APPENDIX A  
NOTICE OF PREPARATION AND COMMENT LETTERS

## Notice of Preparation of a Program Environmental Impact Report for the Six Basins Strategic Plan

RE: SCH# 2018091020 Strategic Plan for the Sixth Basins Project, Los Angeles and San Bernardino Counties

THE SIX BASINS STRATEGIC PLAN (PROJECT)  
NOTICE OF PREPARATION FOR PROGRAM ENVIRONMENTAL IMPACT REPORT

**Figure 1:** Potential groundwater dependent ecosystems within the Six Basins project area.

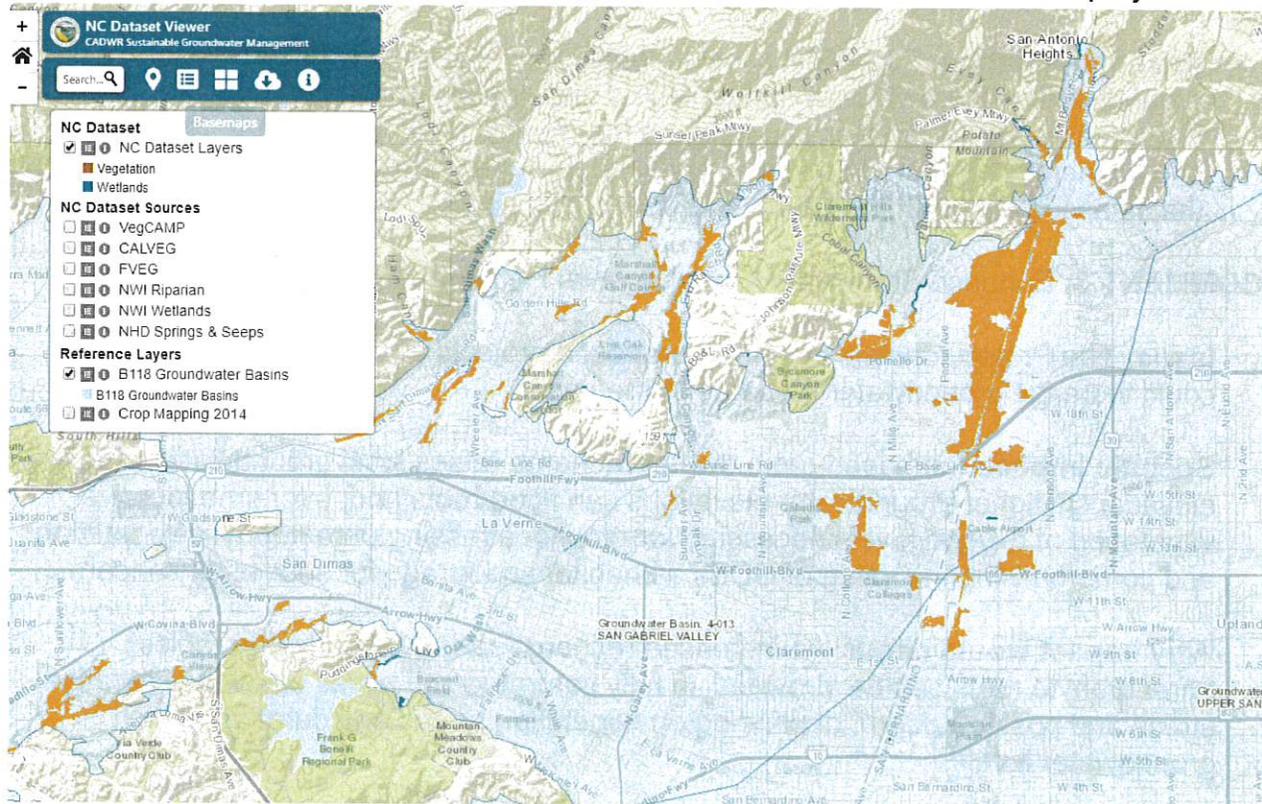
The DWR’s [Natural Communities Commonly Associated with Groundwater Dataset](#) identifies many potential GDEs in the Project’s geographic scope (DWR 2018) (Figure 1). The potential GDEs identified in orange in Figure 1 likely comprise phreatophytic vegetation, which rely on water supply from the groundwater table. This vegetation is a critical contributor to habitat and forage for a wide range of species and can be sensitive to depth to groundwater threshold impacts (Naumburg et al. 2005, Froend

**Recommendations:** The PEIR should verify the GDE existence and identify vegetated communities (e.g., species compositions) and associated rooting depths/optimal groundwater table elevations. This will allow Project proponents to: 1) determine which proposed project actions are most likely to impact GDEs based on basin hydrology, 2) deploy representative groundwater monitoring stations within GDEs to track groundwater levels and vegetation responses over time, 3) establish thresholds/triggers for adaptive management to respond to stressed vegetation as needed. There is potential that the proposed projects could benefit GDEs; if habitat benefits are expected based on PEIR development, monitoring should still be utilized to confirm outcomes.
